ADDENDUM NO. 002

RE: Water System Capital Improvements – Phase II
For Town of Bluefield
T&L Project No. 16176

DATE: June 8, 2023

E102

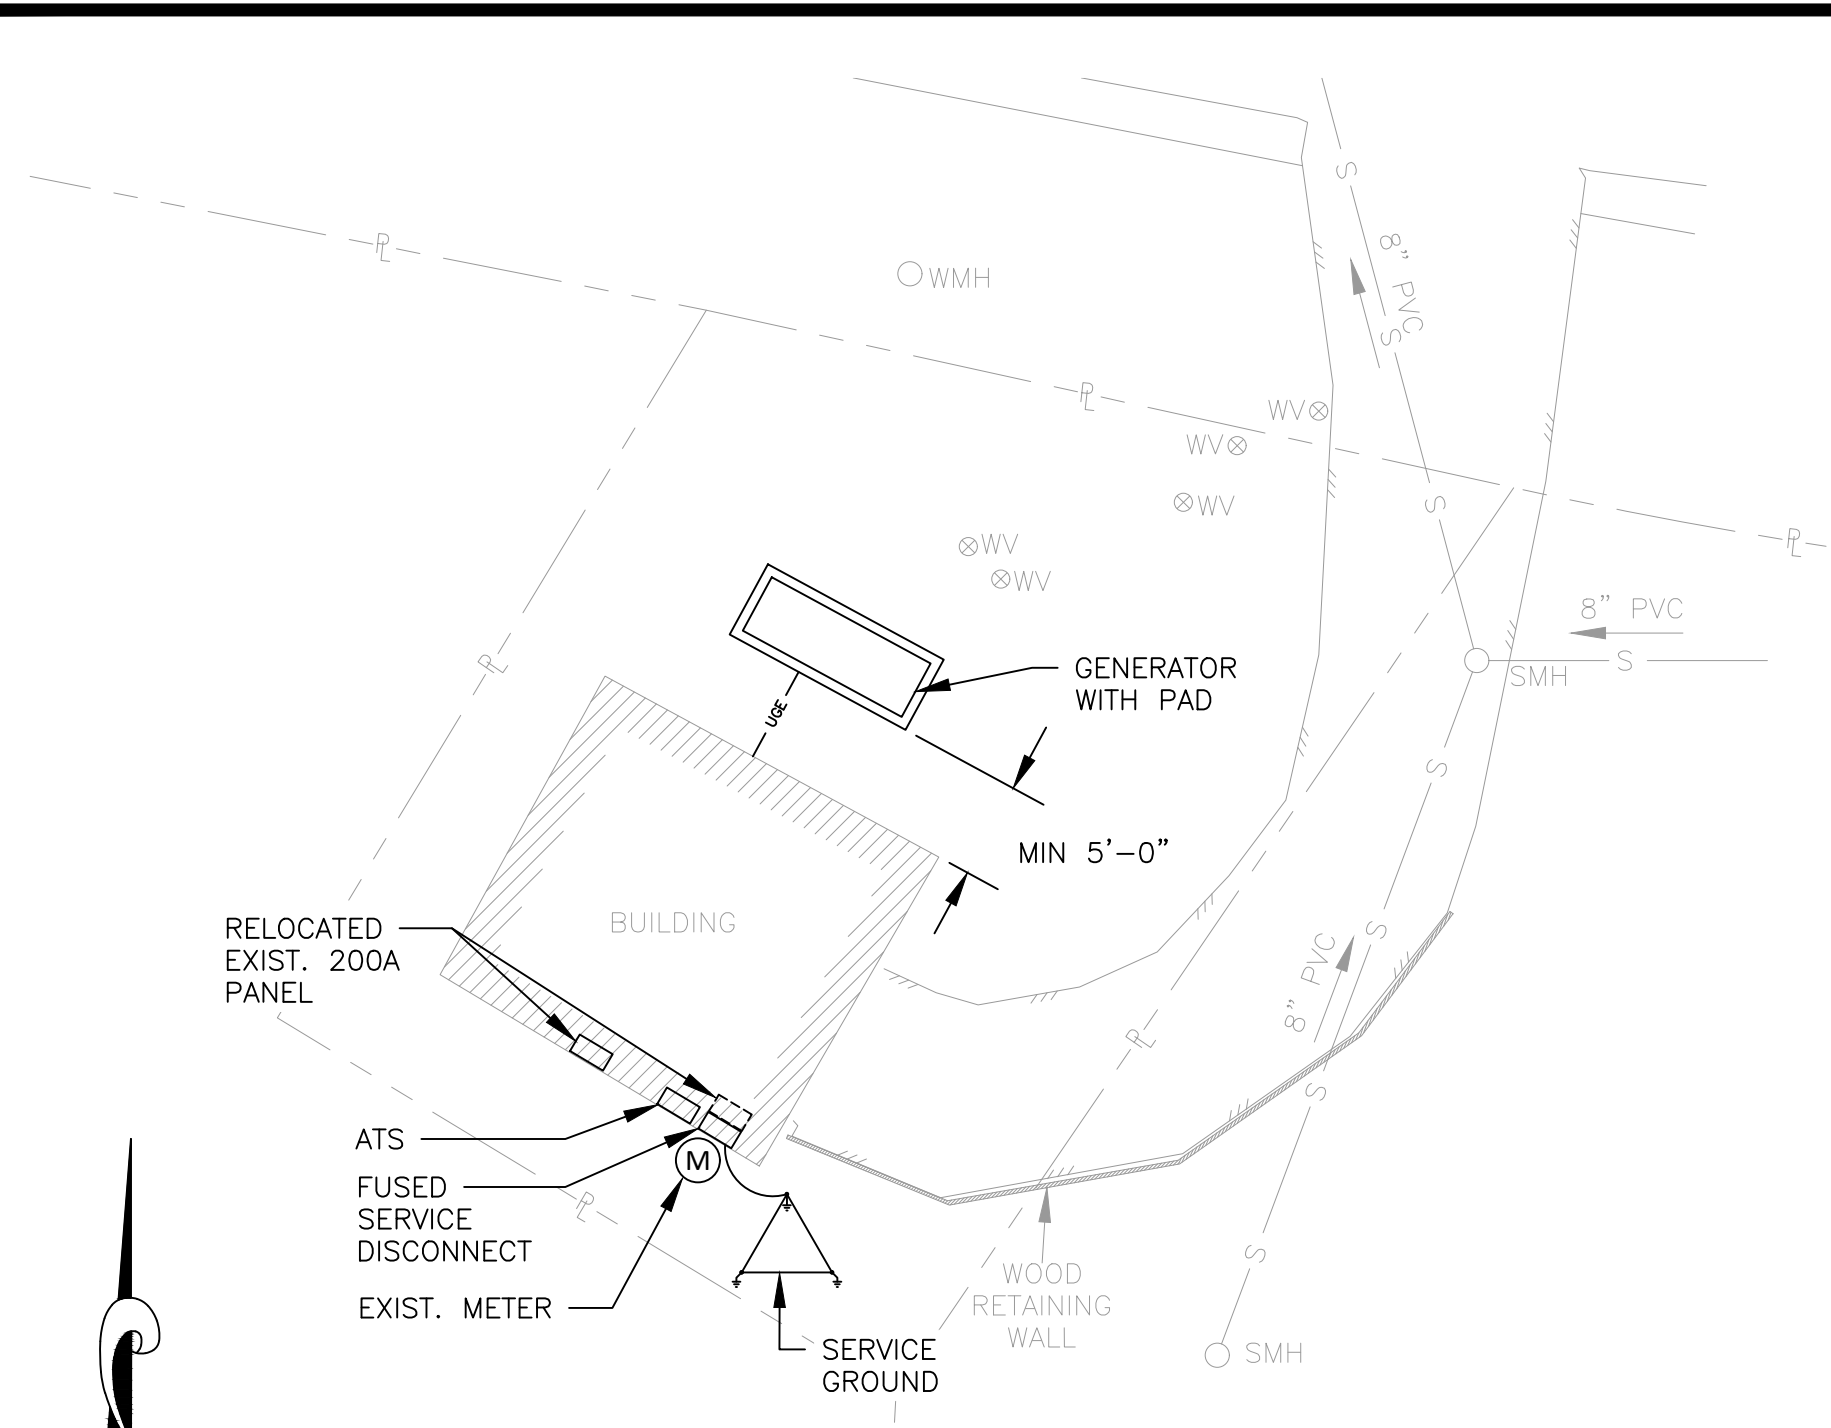
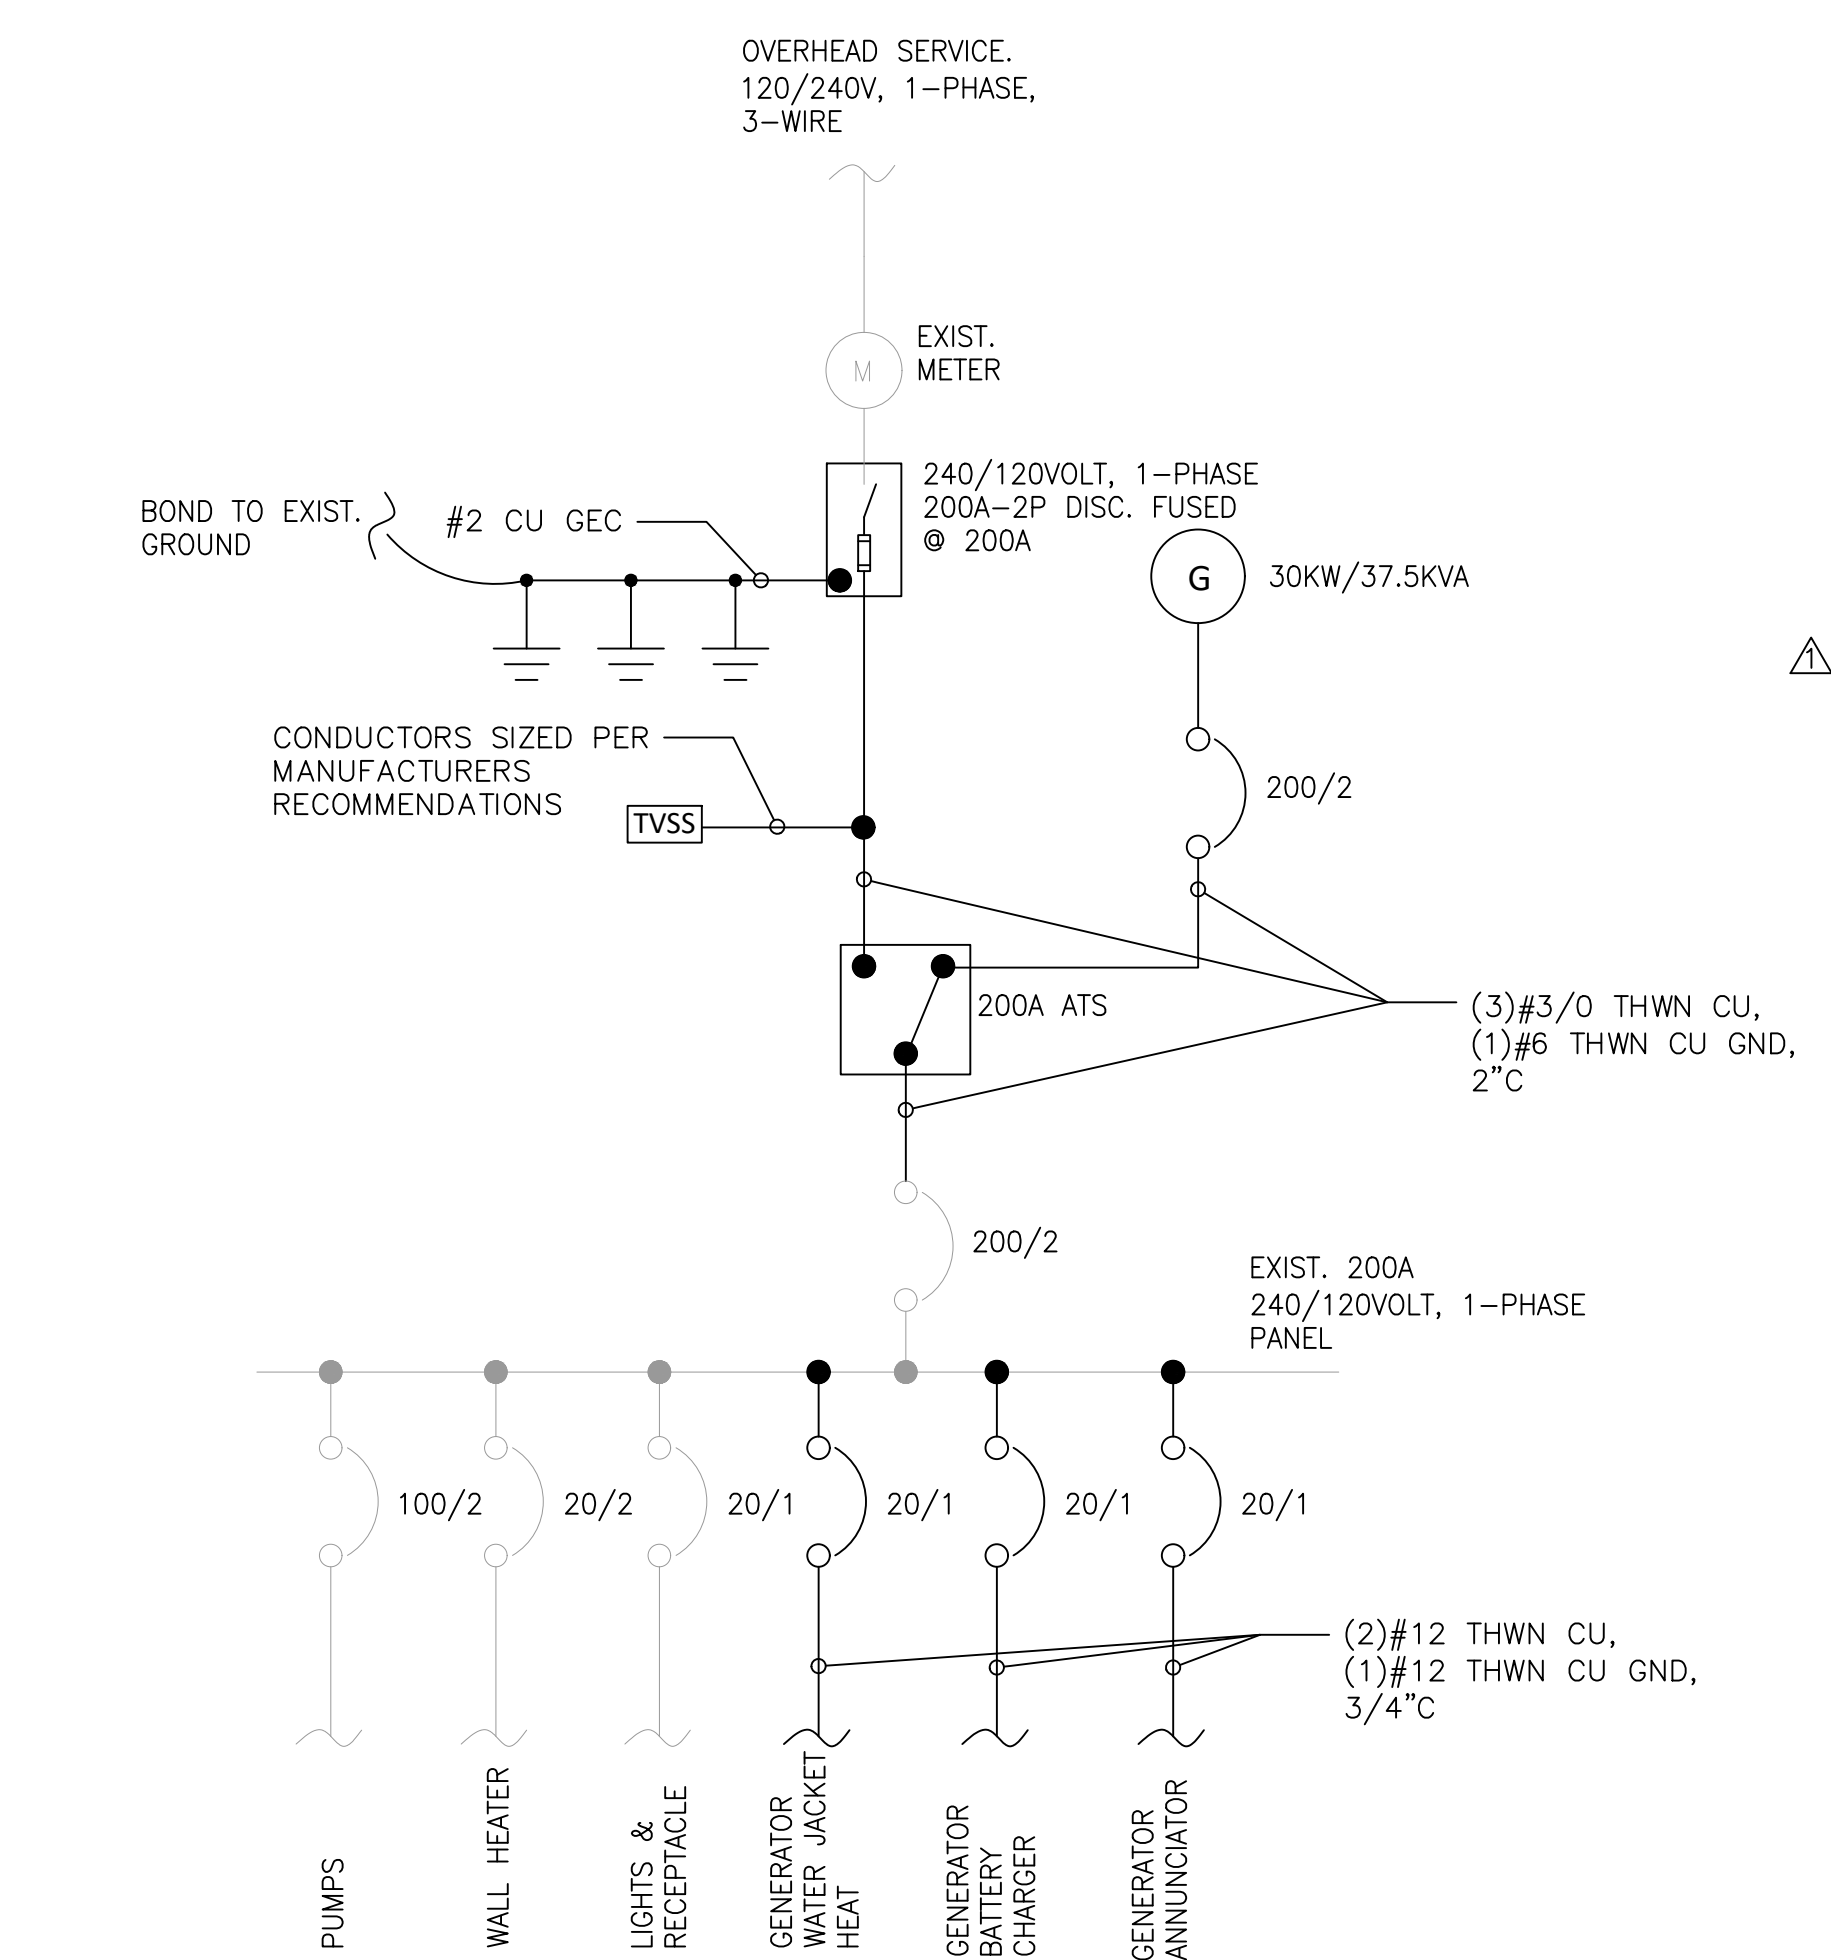
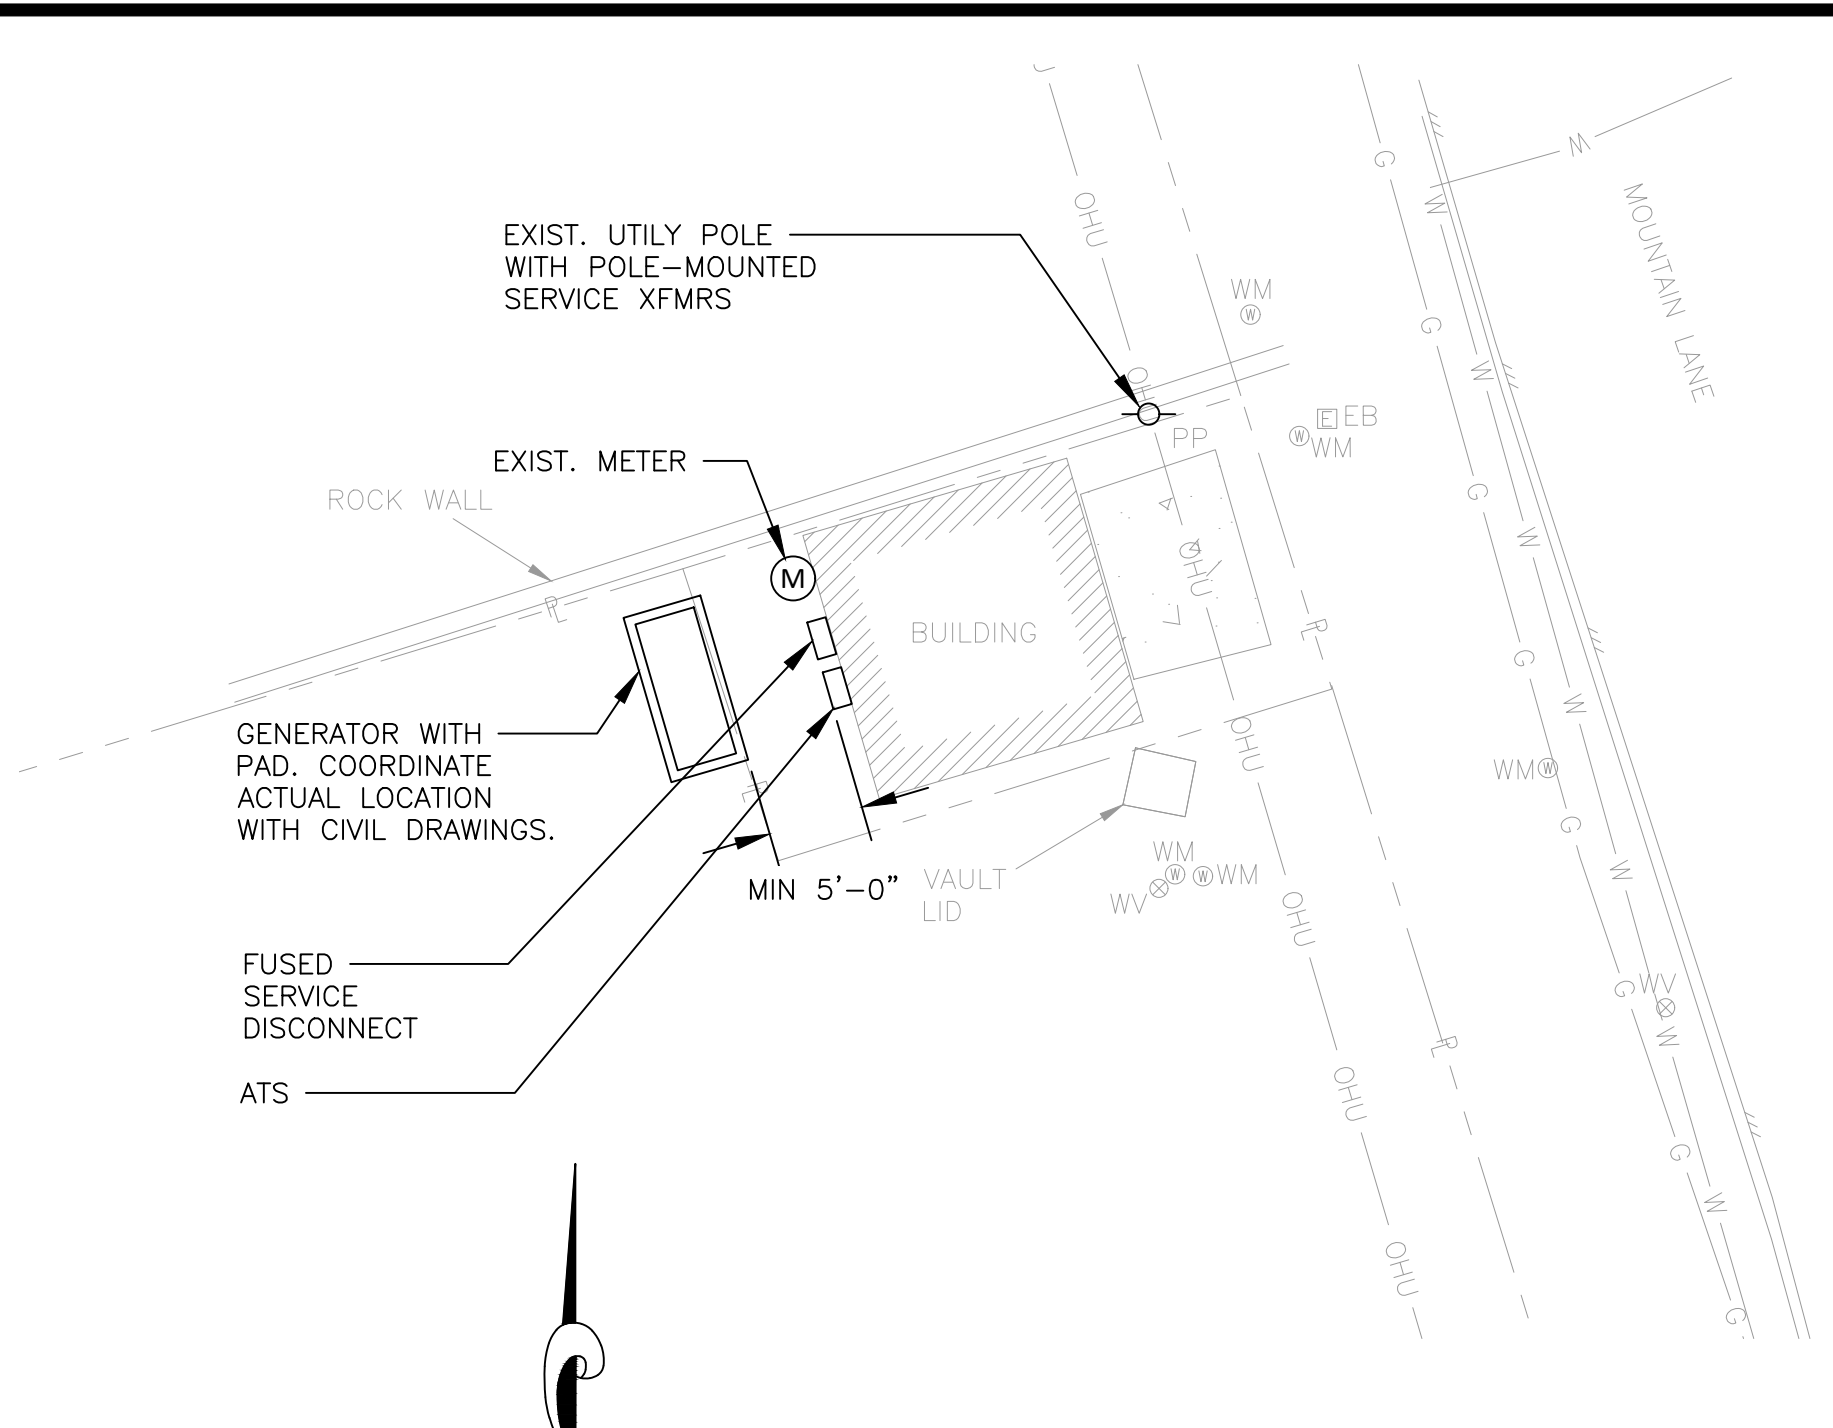
1. All new camera systems shall be on separate networks from the main station controls.
2. The 0.8PF stated on Risers E102 and E103 applies to both single or three-phase power.
3. The remote is to provide access on the exterior of the generator enclosure such that fuel is not spilled inside of the generator enclosure. Fuel fill shall be lockable.
4. Pipe material for lines between the basin and outfall shall be ductile iron as specified in Specification Section 33 1116 – Water Utility Distribution and Treatment Piping and Valves.

1. Drawing C103 has been revised to add new 12' wide double swing gates to the existing fencing between the park and the water treatment plan and add hatching to delineate the area adjacent to the basins where additional earthwork shall be performed to satisfy flood mitigation requirements. The revised drawing is enclosed.
2. Drawing C201 has been revised to add clarification for the ornamental aluminum fencing. The revised drawing is enclosed.
3. Drawing C207 has been revised to clarify the motor requirements for the Raw Water Pump. The revised drawing is enclosed.
4. Drawing E101 has been revised to shift text for visibility. The revised drawing is enclosed.
5. Drawings E102 and E103:
 - a. Additional information has been provided in regards to startup requirements.
 - b. Each ATS withstand requirement value based off of given fault current has been corrected.

- EXISTING GROUND ELECTRODE CONDUCTOR MAY BE REUSED IF CONDUCTOR CAN BE TRANSFERRED WITHOUT SPLICING AND IS SIZED AS INDICATED.
 - THE MAXIMUM AVAILABLE FAULT CURRENT FOR THE BRIERWOOD PUMP STATION IS 921A. ALL INSTALLED EQUIPMENT MUST MEET OR EXCEED THIS RATING. PROVIDE LABEL FOR NEW SERVICE DISCONNECT IN ACCORDANCE WITH THE NEC 110.24 'AVAILABLE FAULT CURRENT 921AMPS, 02/21/2023.'

- THE MAXIMUM AVAILABLE FAULT CURRENT FOR KERSEY PUMP STATION IS 1766A. ALL INSTALLED EQUIPMENT MUST MEET OR EXCEED THIS RATING. PROVIDE LABEL FOR NEW SERVICE DISCONNECT IN ACCORDANCE WITH THE NEC 110.24 'AVAILABLE FAULT CURRENT 1766AMPS, 02/21/2023.'
